# CITY OF CONWAY, ARKANSAS HISTORIC DISTRICT COMMISSION

August 22, 2022 • 5:30pm • 1111 Main Street

## HISTORIC DISTRICT COMMISSION

August 22, 2022

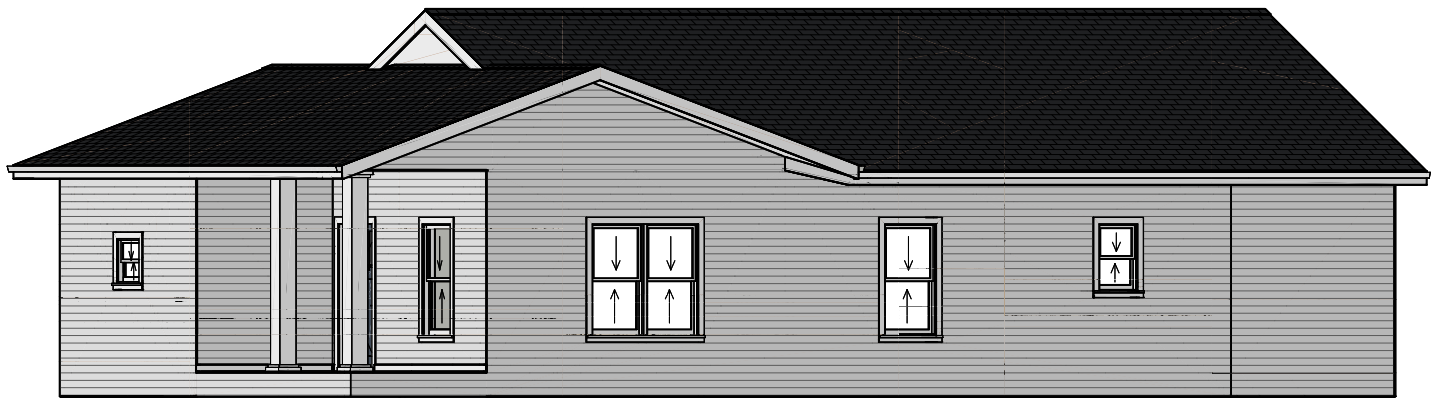
*The applicant is proposing to keep the existing windows on the structure and add a small new window in the front bathroom. A bathroom/laundry room appears to have been added on to the house at some point in the past and has no window. Normally, a large double window would be located there. However, a window is not practical in this location. Recommend requiring an architectural feature such as two sets of false shutters with Craftsman styling in this location in-lieu of the proposed small window, which can be added on the north façade wall. The proposed door is appropriate. Recommend requiring the front columns be at least 8" in diameter.*

*The large blank front façade wall is existing, but is not compatible with the surrounding structures.*

*The design cannot meet this requirement due to the presence of a front bathroom.*

1. Require two sets of false shutters in a craftsman style to mimic the presence of windows on the front façade and move the small proposed window to the north façade.
2. Require the proposed columns be at least 8" in width.
3. Require use of Hardie® siding or wood lap siding be used, if the siding is replaced.
4. Require fascia and soffits to be finished with wood or wood equivalent construction (Hardieboard).
5. Require all windows be 1-one-1 design and feature wide trim, if replaced.
6. All HVAC and mechanical equipment shall be screened or placed in a manner to reduce visibility from the street.
7. If the driveway is improved, it may be improved with a ribbon driveway or a driveway no wider than 12'.
8. Submit revised drawings to the Planning Director for approval prior to release of the Certificate of Appropriateness.

4 FRONT ELEVATION NEW  
1/8" = 1'-0"

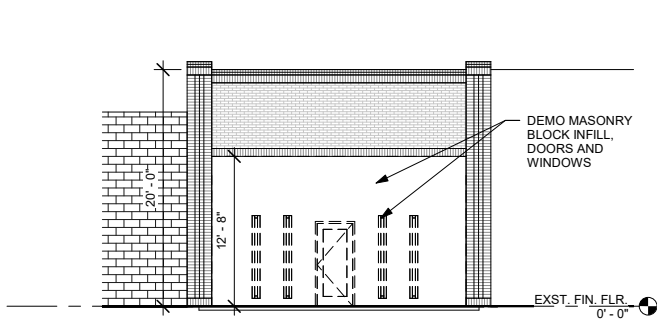
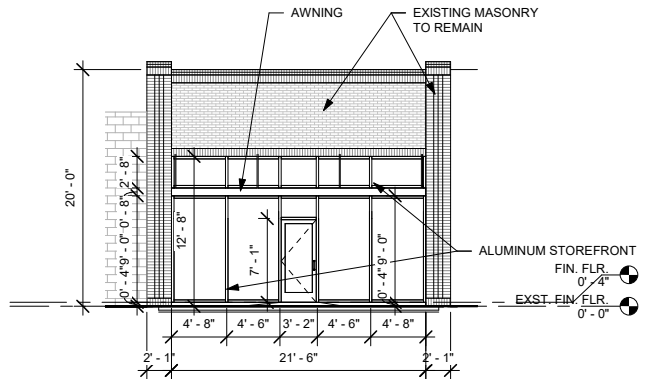
*The application meets this requirement. The existing storefront will be replaced with almost all glazing.*

*The application meets requirements.*

1. All glass shall be transparent or have minimal tinting unless required by separate regulation.

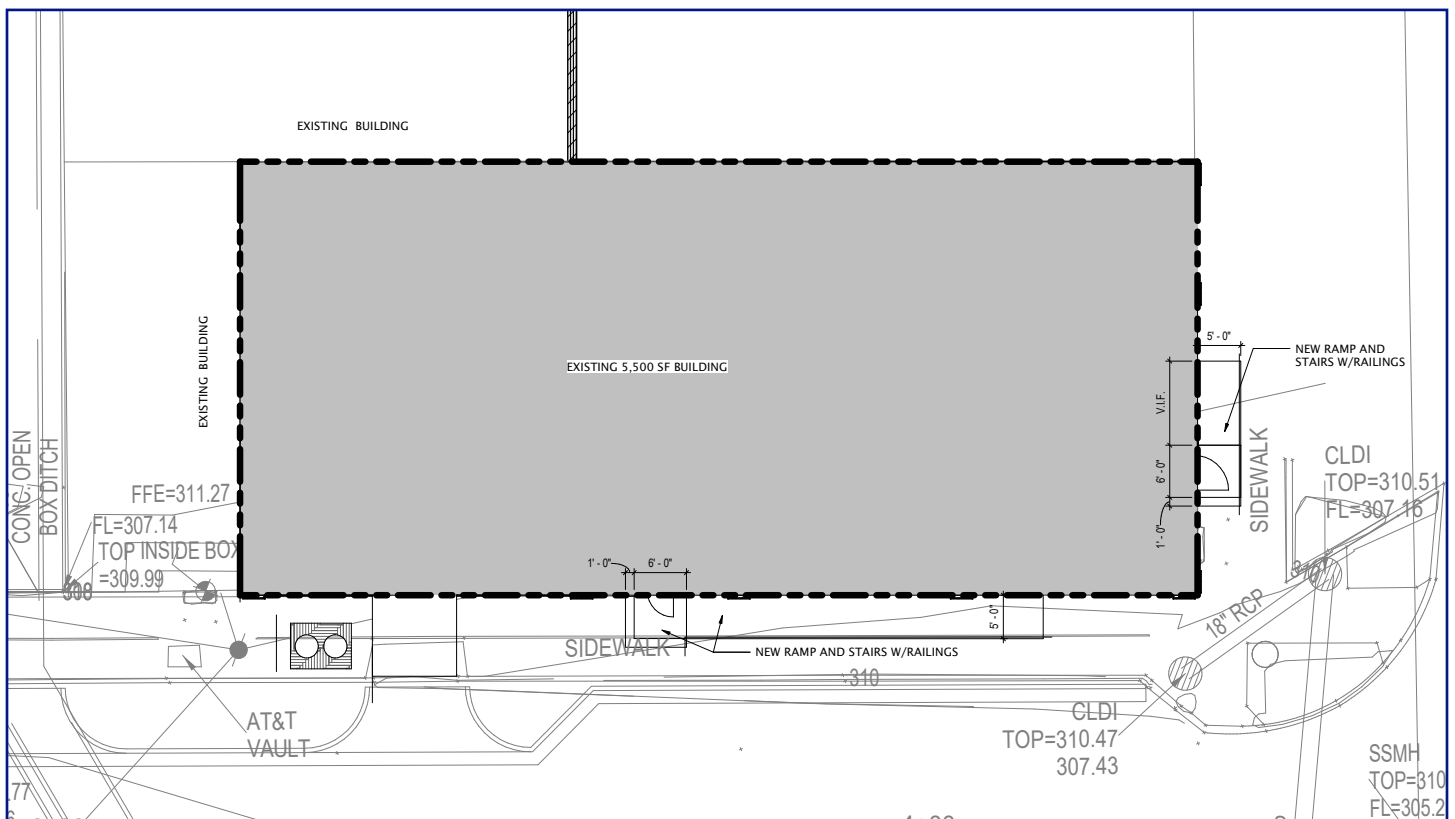
*The application meets this requirement. Almost all bricked in or existing enclosed windows and entries will be replaced, except the existing storefront for 804 Chestnut St. Recommend requiring this area be replaced with new glazing, mural, or architectural feature.*

*The applicant is proposing to add thin veneer brick in key areas on the building and paint the existing 1980s stucco panels. Removal of the stucco can't be easily done without damaging the brick underneath. The application meets requirements.*

*The proposed signage appears to comply with the Conway Zoning Code. Separate permitting shall be required. Recommend allowing additional signs in the circle design features on the parapets along both street frontages or allowing use of neon or simulated neon to light signage.*

1. The existing entry for 804 Chestnut St shall be replaced with glazing, mural, or architectural feature.
2. The proposed structural reinforcement “diamond” braces may covered with architectural trim.
3. All glass shall be transparent or have minimal tinting unless required by separate regulation.
4. Additional signage shall be permitted in the circle design features on the parapets of both street frontages.
5. Allow the use of neon lighting or simulated neon lighting in building signage.
6. Revised plans shall be approved by the Planning Director prior to issuance of a Certificate of Appropriateness.
